Design & Access Statement

Rev A
20/08/2015

107 Gray's Inn Road
Charles Darwin House Ltd.

The application is submitted on behalf of Charles Darwin House Ltd. to obtain planning permission for the additions made to the office building, namely the inclusion of louvred enclosures to the side of the rear facade at ground floor level and the addition of a Plant Room on the fourth floor.

Proposed Roof Plan - Drawing 3257-2155H

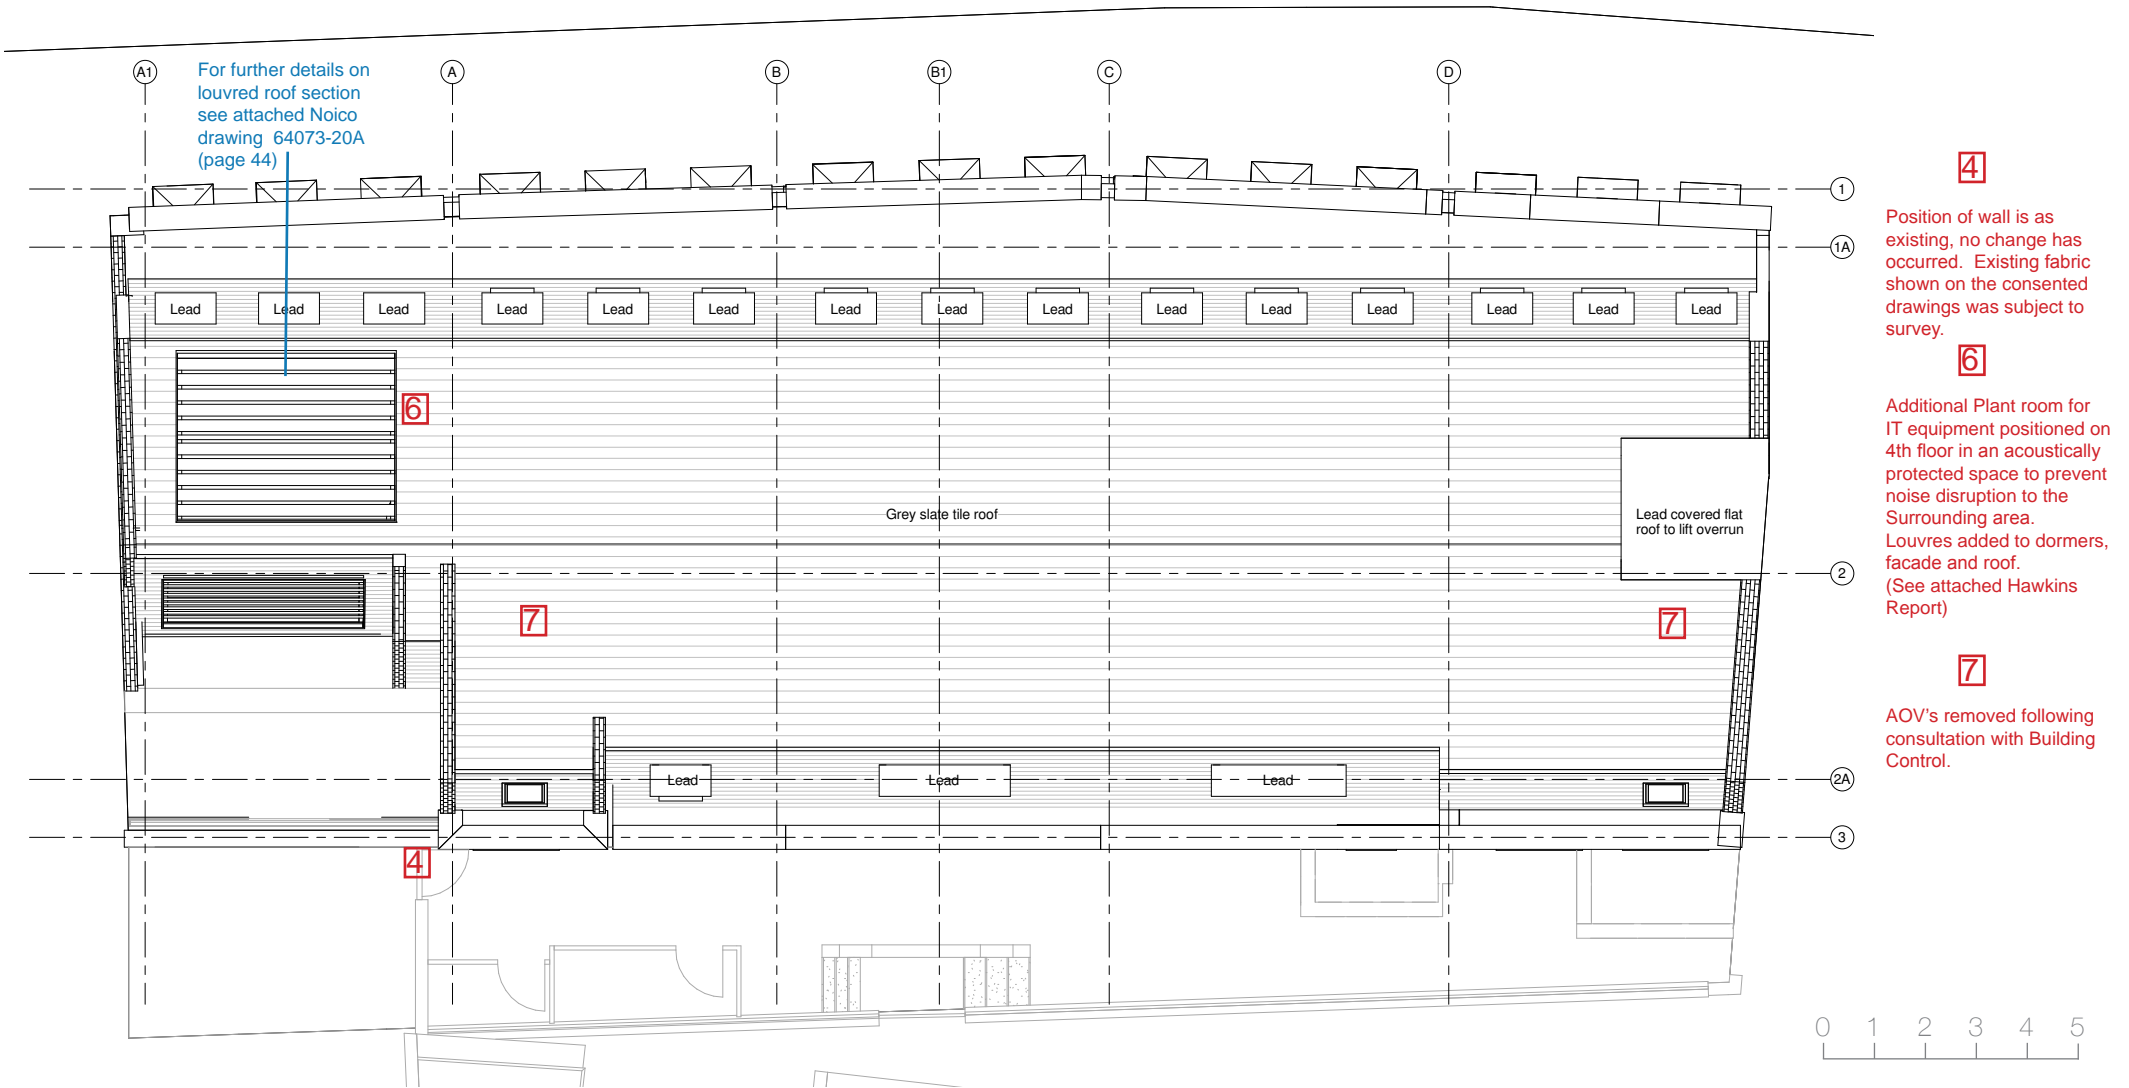
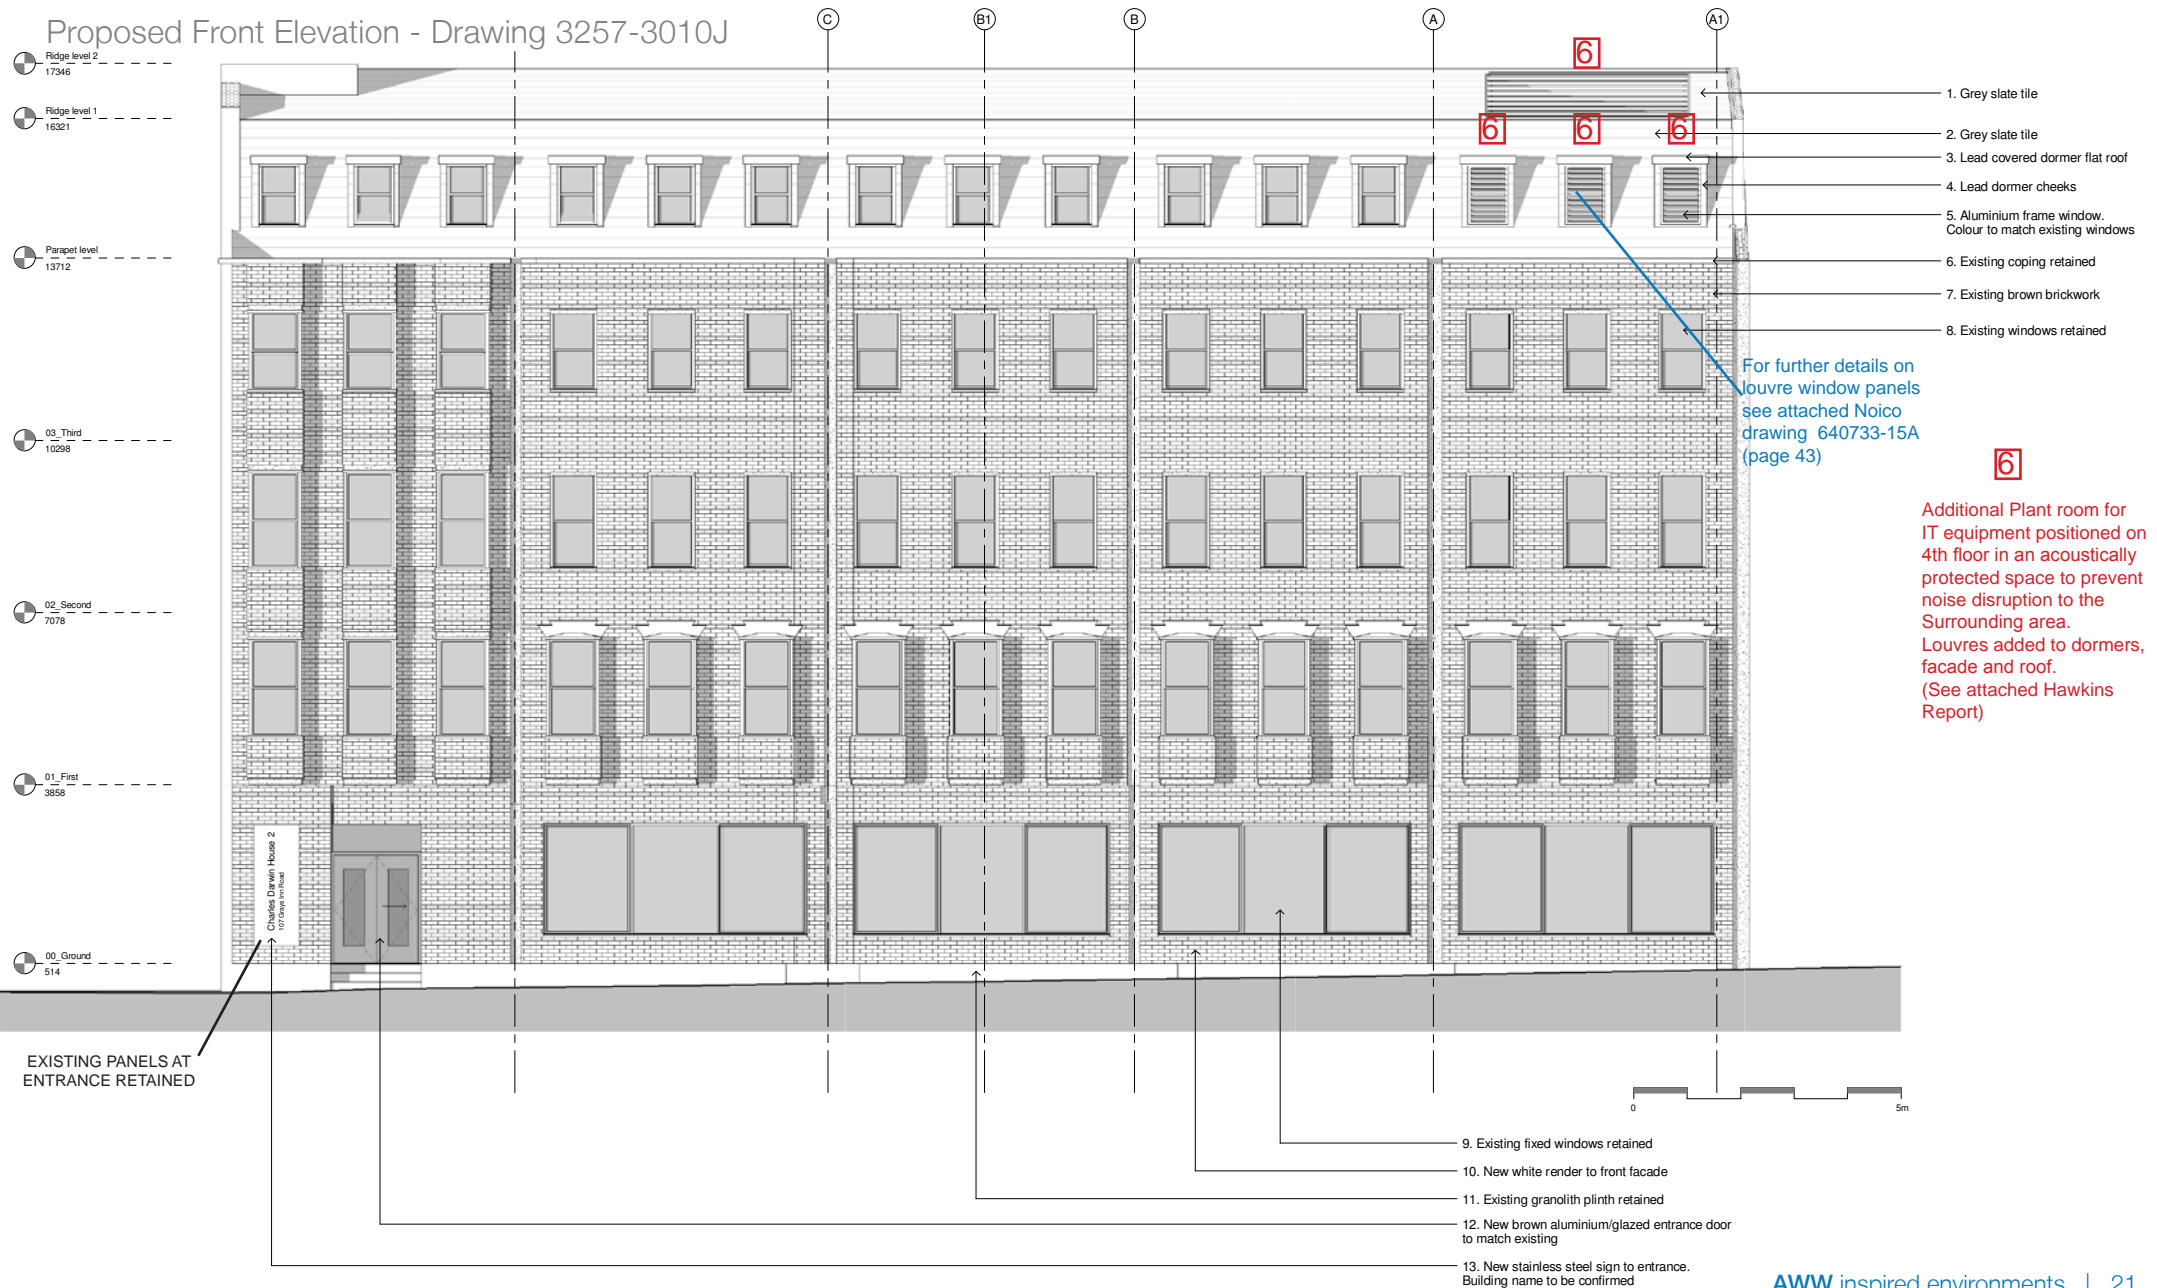
4
Position of wall is as existing, no change has occurred. Existing fabric shown on the consented drawings was subject to survey.

6
Additional Plant room for IT equipment positioned on 4th floor in an acoustically protected space to prevent noise disruption to the Surrounding area. Louvres added to dormers, facade and roof. (See attached Hawkins Report)

7
AOV's removed following consultation with Building Control.
